# DESIGN EXCELLENCE ADVISORY PANEL RECOMMENDATIONS

**Address** 4 – 8 Uhrig Road, LIDCOMBE

**Date** 29 May 2020

Application Number	DA/501/2019
Assessing Officer	Andrew Golden
Applicant/Proponent	Karimbla Properties (No. 51) Pty Ltd
Architect and Registration Number	DKO Architecture (NSW) Pty Ltd Nick Byrne, Reg no – 7806 Ian Lim, Reg no – 8473
Urban Designer	
Landscape Architect	
Planner	
Others in attendance

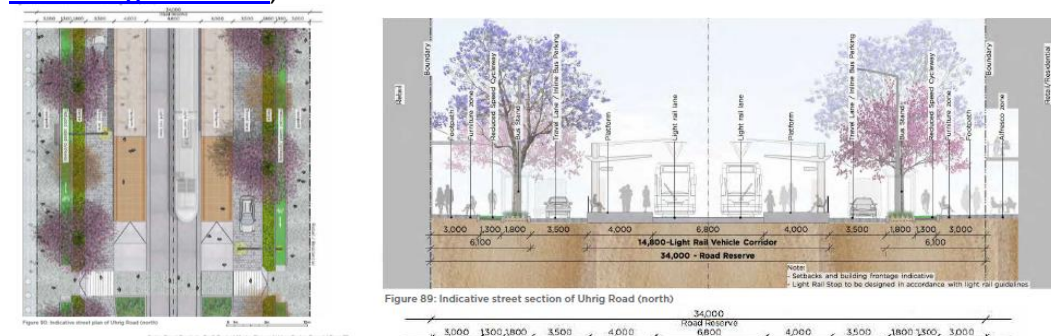
1. The public domain is to be designed in accordance with the street section illustrated in the Draft DCP 18 (Appendix 2) - Uhrig Road North/ Town Centre (section Figure 5). While the project is not currently underway, CoP wishes to futureproof the streetscape as much as possible and this section outlines the necessary provisions for Parramatta Light Rail Phase 2 to protect the trees from any possible disruption. (inserted below)

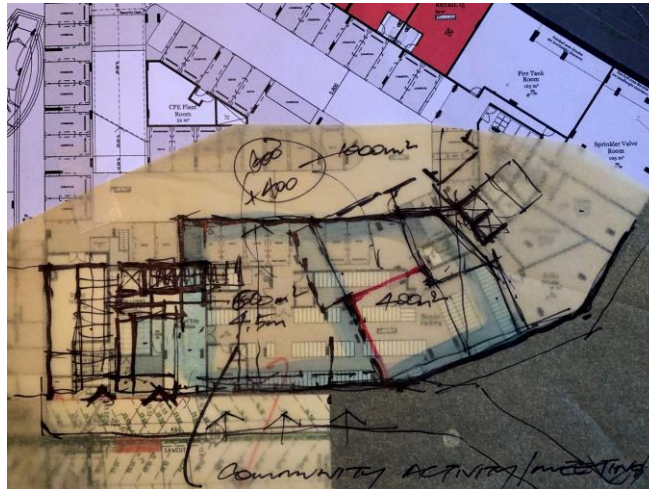
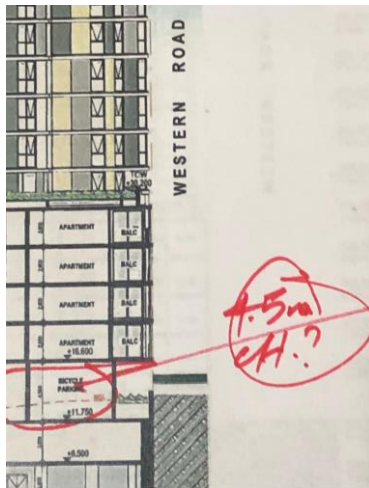
9. Provision options for the Community Centre were discussed, and it was understood by the Panel that the Ground Floor location within the car park (only available to DEAP on 26/3/20) was in response to CoP community services request for presence off the public realm of Uhrig Rd. Previously this had been in the same location on Level 3 above to allow skylights from the podium terrace. The Panel expressed its major concerns about both these options due to poor access, impacts from structure and services, minimal or non-existent external views, and the limited ceiling height of less than 3m that would be available for a 1000sq.m space.

10. An alternative location for the Community Centre was proposed by the Panel that would involve moving the bicycle parking and 'end of trip' amenities to the Ground Level parking area with similar access from a small foyer off Uhrig Rd. The space then available facing Western Rd was considered to offer a superior outcome with around 600sq.m having a ceiling height approx 4.5m and 400sq.m with just under 3m. While not directly off Uhrig Rd, there would be potential for good access, street presence and visibility, natural light and a capacity for a range of uses likely when residents occupy the complex and have input.
